METROPOLITAN GOVERNMENT OF NASHVILLE AND DAVIDSON COUNTY

STAFF RECOMMENDATION
2002-2002 ½ Eastland Avenue
September 17, 2014

Application: Demolition; New construction-infill
District: Eastwood Neighborhood Conservation Zoning Overlay
Council District: 06
Map and Parcel Number: 08306038400
Applicant: John Root, architect
Project Lead: Sean Alexander, sean.alexander@nashville.gov

ARCHITECTURAL SITE PLAN

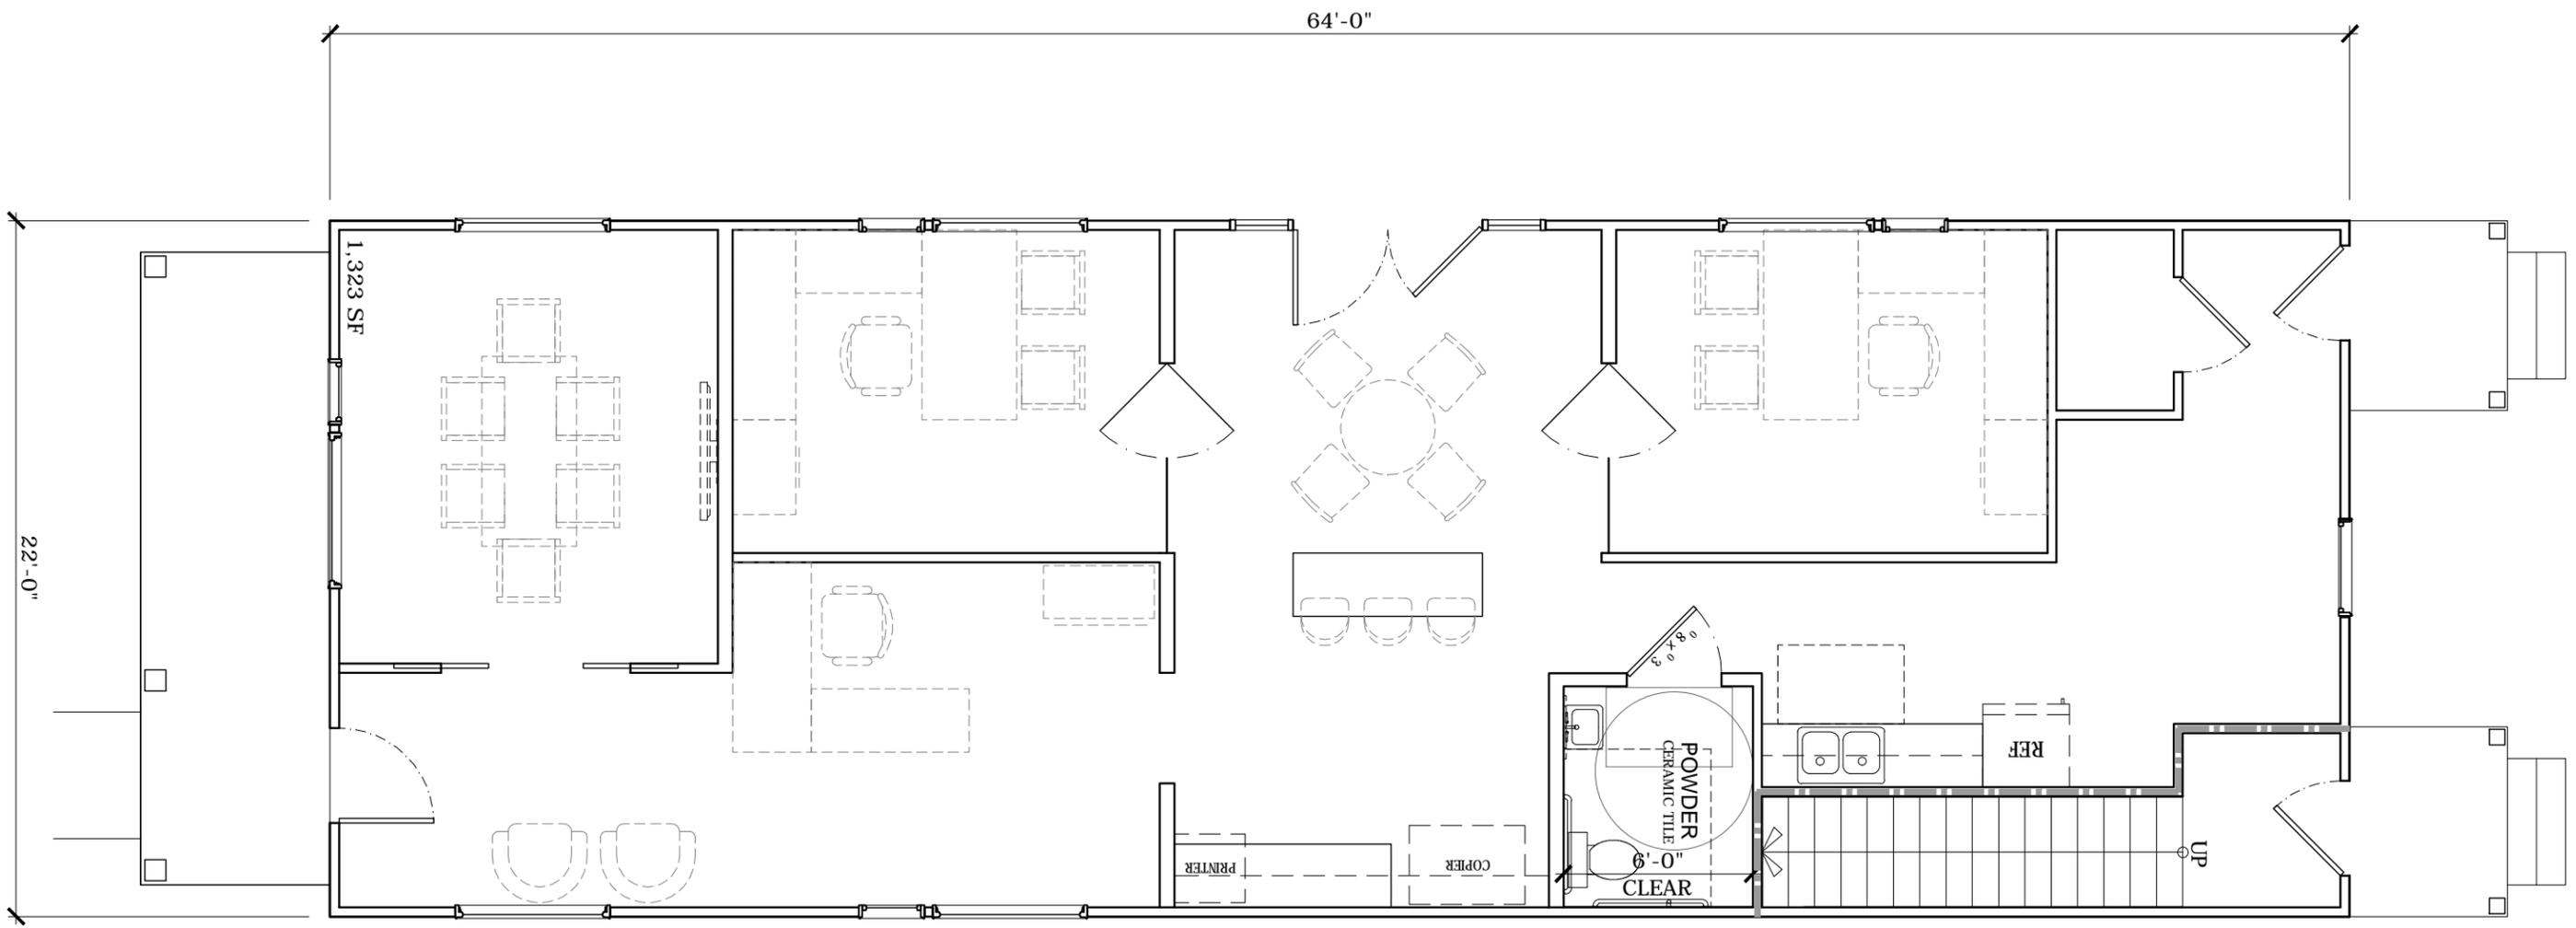
The site plan has also been revised to clarify that the building's side setbacks would be five feet, four inches (5'-4") from their shared property line, with three foot (3') side setbacks toward the adjacent properties on the left and right. With these setbacks, the two new buildings would have ten feet, eight inches (10'-8") of spacing between them.

A front parking area on the original submittal has been removed.

STREET ELEVATIONS

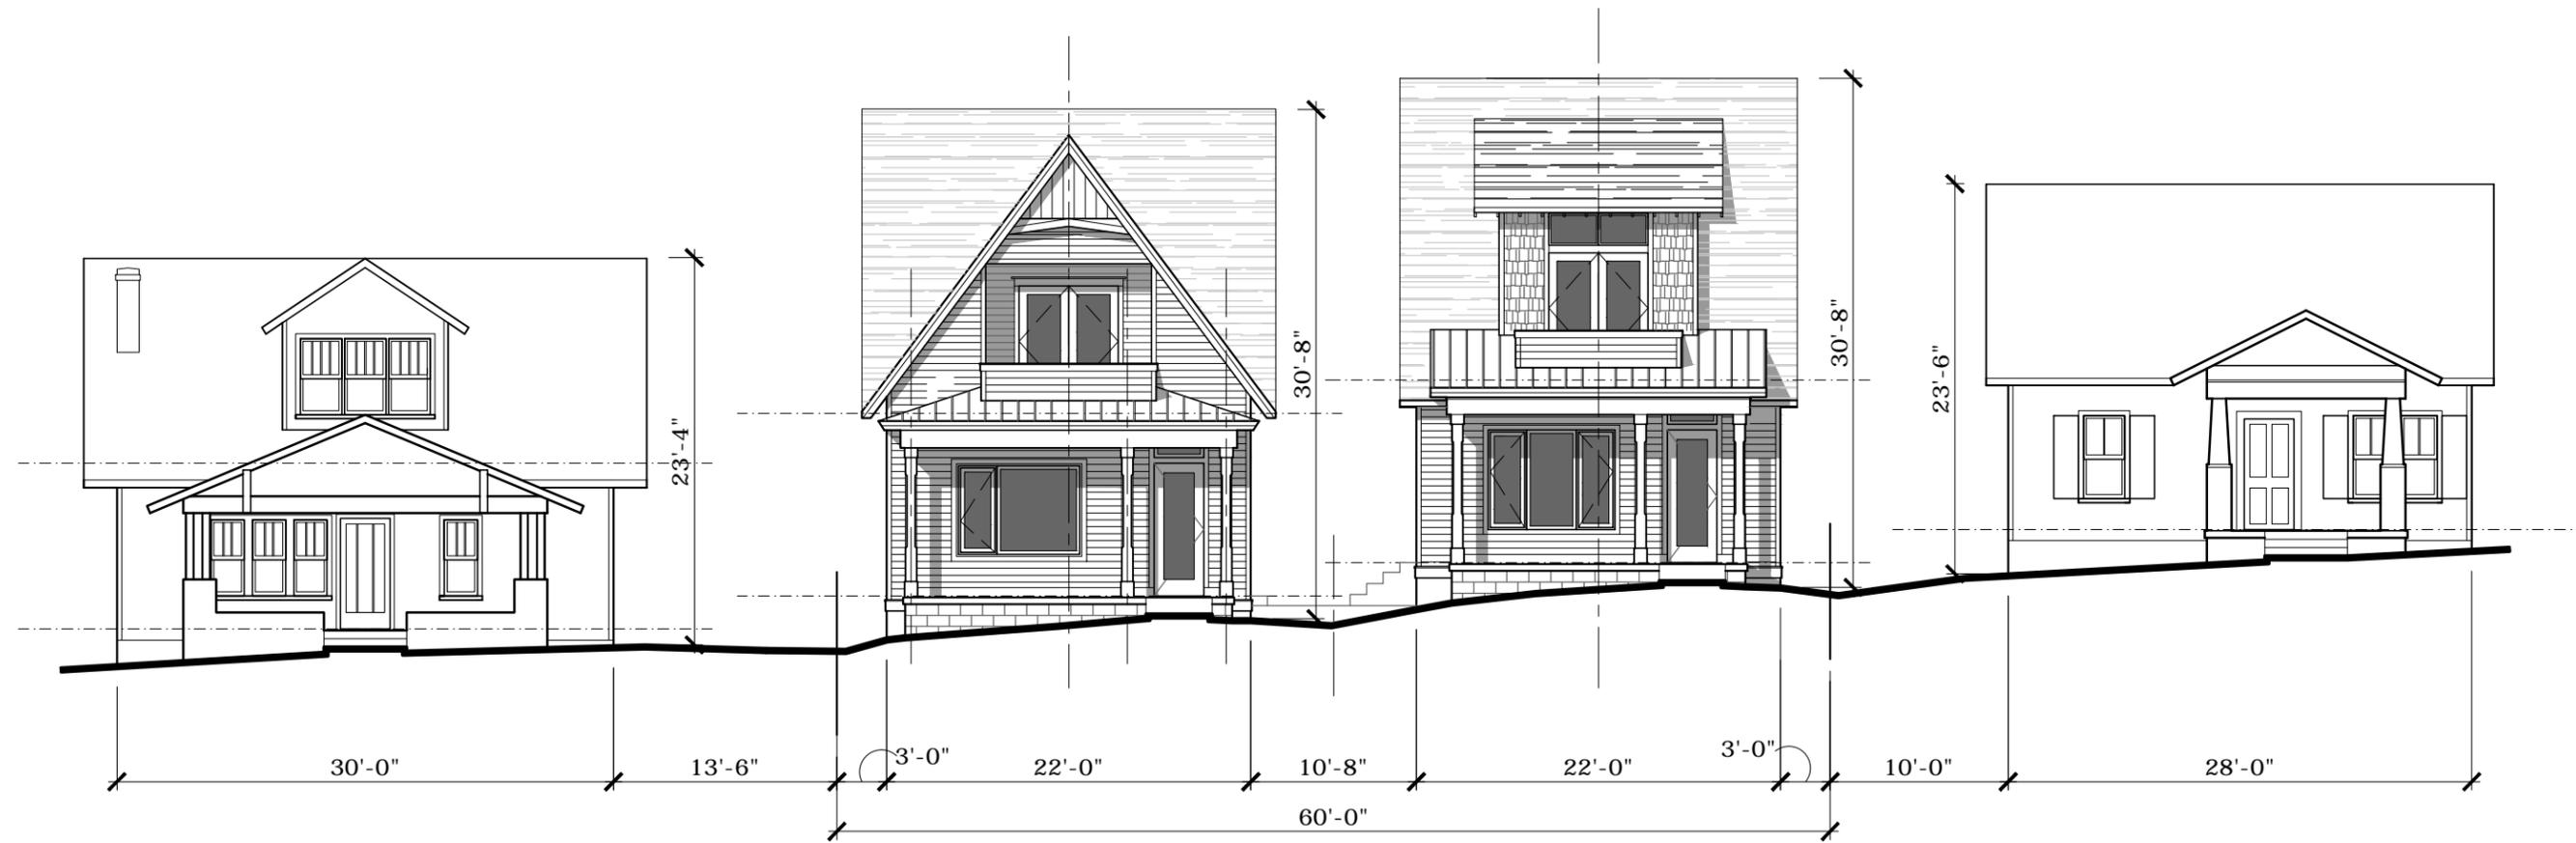
In the revised plans, the front slopes of the asymmetrical gabled roofs are lowered from 12:12 to 10:12, which results in the overall height of the buildings being reduced by one foot (1'). The width of the buildings was not changed.

The Commission discussed the fact that the height needed to be lowered, possibly as much as three feet (3'), and the width expanded. Because the applicant has lowered the buildings by one foot (1') and not altered the width, Staff finds that the revisions do not sufficiently address the concerns about the compatibility of the height and width of the buildings, and the spacing between them.

Staff recommends disapproval of the proposed infill, finding that it does not meet the design guidelines for the Eastwood Neighborhood Conservation Zoning Overlay.
